ADDENDUM TO CONCEPT DA 16-2018-772-1 KINGS HILL DEVELOPMENTS 3221 PACIFIC HIGHWAY, KINGS HILL

The information **below** and **attached** responds to the matters identified during the Regional Planning Panel briefing between Council and KHD on 12 August 2020 (in **bold italics**):

Figure 4 Extent of Precinct 6 within 250m Potential Gas Migration Footprint

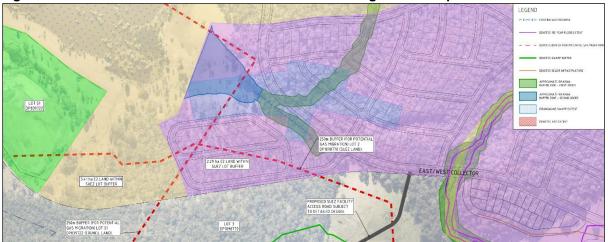
Suez, the current operator of the Composting and Landfill facility, lodged a submission in April 2020 seeking Council's implementation of suitable measures via conditions of consent having regard to the 'siting restrictions' applicable to land uses such as schools and residential dwellings under the NSW EPA *Environmental Guidelines Solid Waste Landfills* (2016). Suez recognise the buffer incorporated into the existing LEP boundaries, but encourage a risk based approach to planning within the 250m footprint of the boundary of any landfill with particular reference to the potential for landfill gas migration.

The Suez submission suggests conditions of consent for Council to apply to any future application for subdivision, in addition to the 12 months of landfill gas monitoring required by the Port Stephens Council DCP prior to applications to subdivide the land within the 250m buffer.

To facilitate consideration, KHD has mapped the extent of urban zoned land within 250m of the former Council landfill site and within 250m of the boundary with Suez (albeit EPA guidelines note the buffer to be applied to the landfill cell, not the property boundary) (refer **Figure 4**).

Although only a relatively small area of developable land within Precinct 6 is within the buffer to each landfill, and although that land is not proposed for subdivision until Stage 15 (some 3 to 8 years post commencement (circa 2025 to 2032)), KHD has commissioned Douglas Partners to conduct the monitoring of landfill gas migration in order to provide confidence in the Concept Proposal prior to determination (see **Attachment F**).

The results to date indicate a CS1 classification based on the procedures outlined in NSW EPA (202) which is defined as 'very low risk'.

#### Figure 5 Extract of Urban Design Place-Making to inform Adjustment to B4 zones (east)

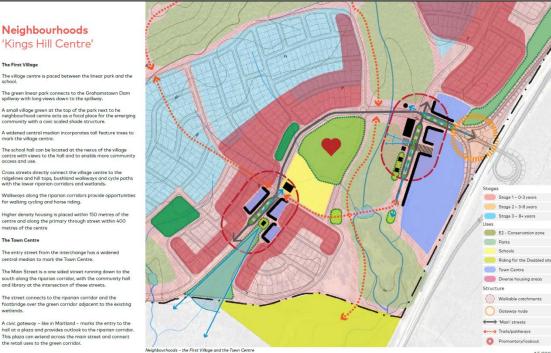
Questions were raised by the Panel in regard to land use planning and design for the B4 mixed use zones. Some areas of B4 land were included in the conservation area and support large stormwater basins. The applicant is to justify how the concept proposal addresses the strategic intent and land use objectives for the B4 zoned land. If B4 land is to be omitted and not developed due to site constraints and/or stormwater strategy, a justification needs to be provided that demonstrates there is sufficient commercially and mixed use zoned land to support the development of the URA.

**Figure 5** indicates the existing B4 zoned areas in the east remain suitably located, but an adjustment to the zone boundaries with the adjoining R1 zoned land is warranted prior to subdivision in this area to facilitate the place-making opportunities identified. **Figure 6** indicates that a relocation of the existing B4 zoned area to a more elevated area toward the north is appropriate. Other B4 zones on KHD's land (along the southern boundary of the site) are no longer surrounded by a critical mass of developable land to support village centre of the kind encouraged by a B4 zoning (albeit such locations remain suitable as activity nodes (for example, local parks) linked to future B4 zones by the east-west collector road and associated shared cycle and pedestrian path).
